SCSI cable media performance working group (SCMP)
November 30, 1999
Rochester, MN

99-328r1

Subject: Approved minutes for the SCSI cable media performance working group CMP on October 26, 27, 1999 in Huntington Beach CA

Comments against SPI-3 rev 10

Add the following figure x describing the test fixture to section E.3.1.2 with the title "Test fixture for single ended capacitance measurement".

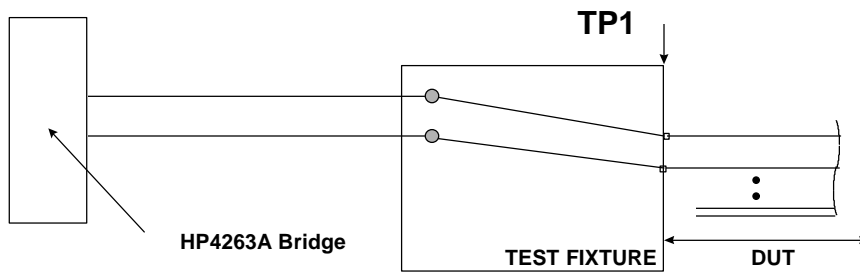
In section E.3.1.2

change: See E.2.2.2 for appropriate test fixtures.

To: Figure x shows the configuration to use for this measurement procedure.

Refer to Figure x for the proper test configuration.
[Add a new Figure x shown below titled "Test fixture for differential capacitance measurements"].

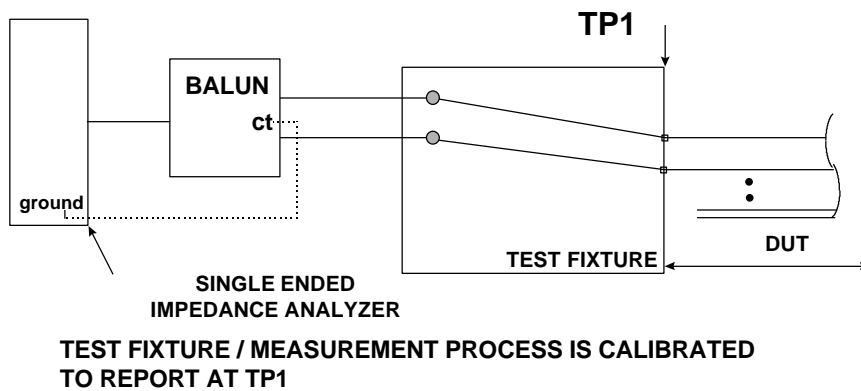
In section E.3.2.2

Change:

See E.2.2.2 for appropriate test fixtures.

To:

Add new figure x given below showing the test fixture with the title "Propagation time measurement setup".

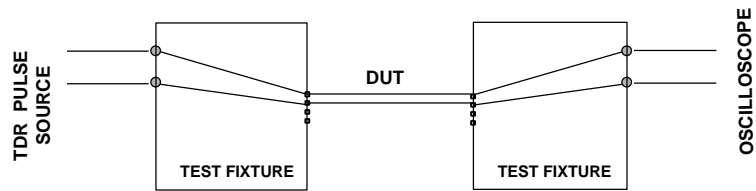
In section E.5.2 change:

See E.2.2.2 for appropriate test fixtures.

To: See Figure x for appropriate test fixture.
